**Amendments to the Drawings:**

ANNOTATED SHEET  
TO SHOW  
CHANGES MADE

WO2005/000611

Fig. 3

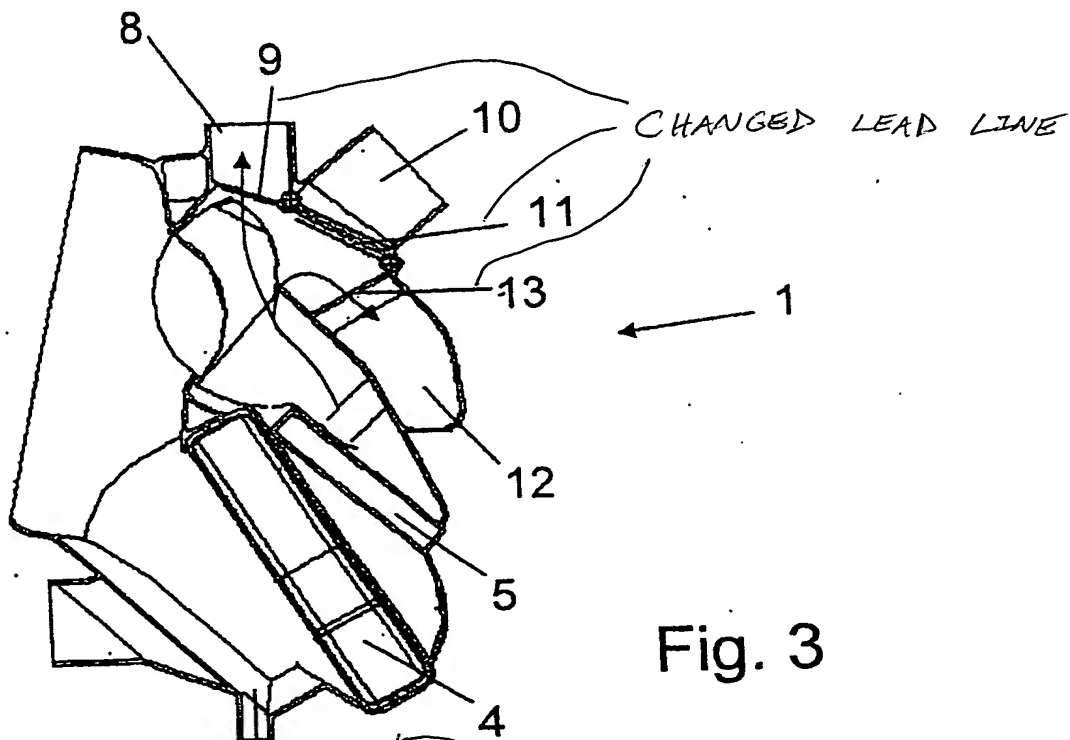
The specific changes which have been made to the Figures are: changing the lead lines for items 9, 11, and 13 in Figure 3, and adding reference numerals to Figures 4-10 and 12.

DELETED

Fig. 5

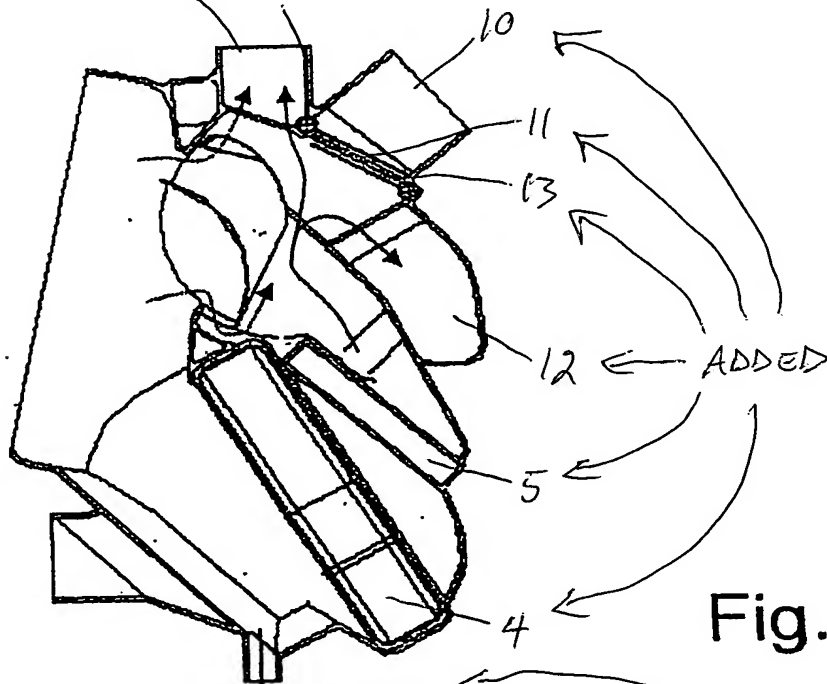
ADDED

DELETED

Fig. 6

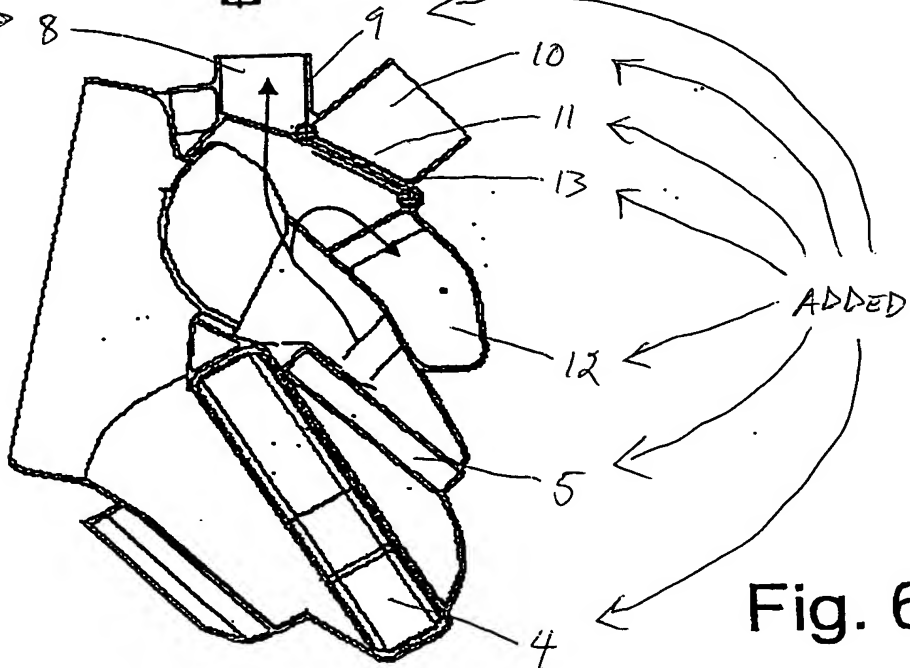
ADDED

Fig. 7

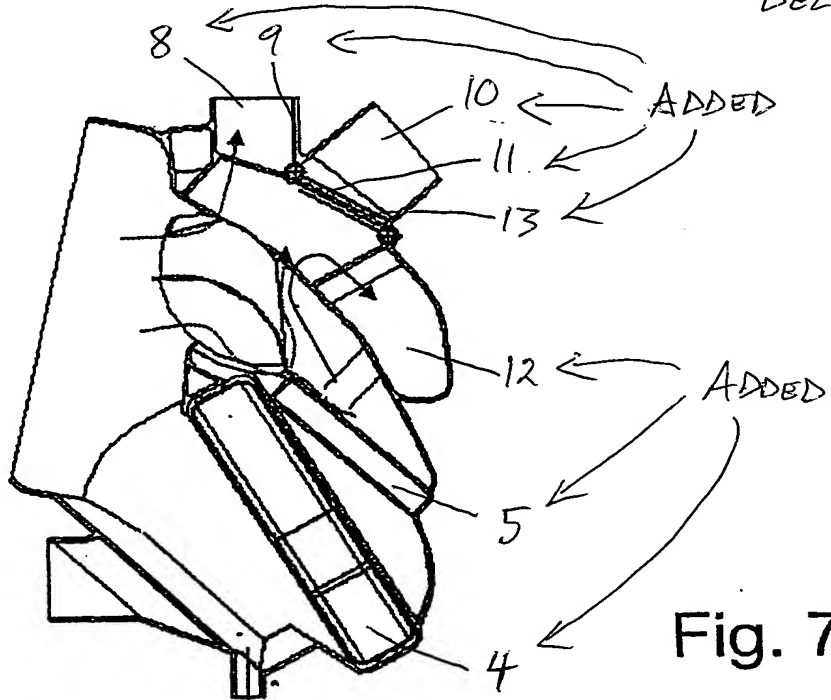
DELETED

Fig. 8

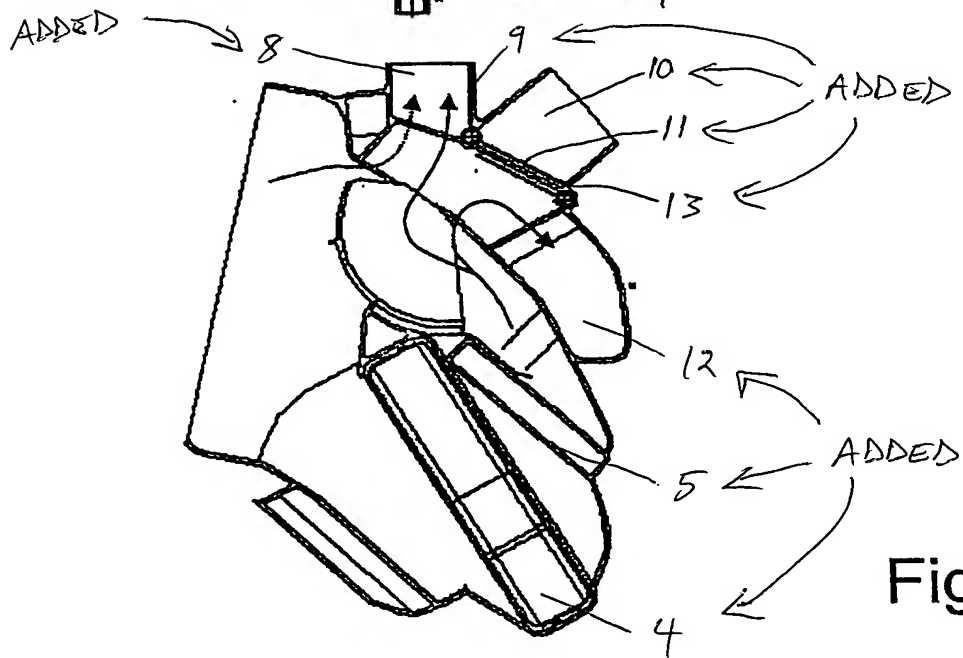
DELETED

Fig. 10

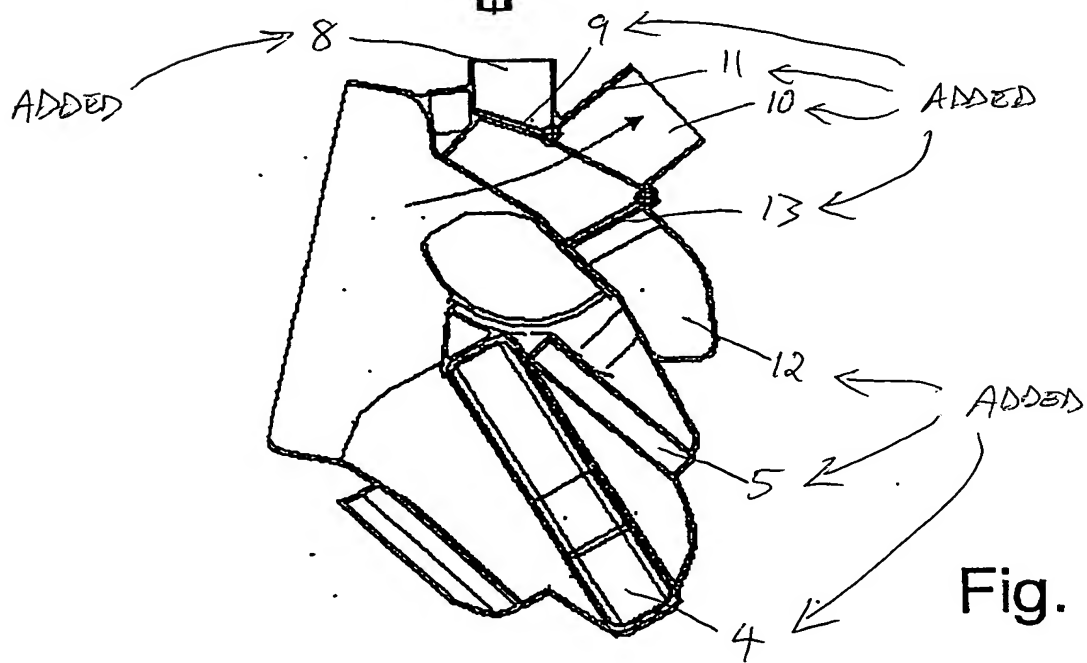
DELETED
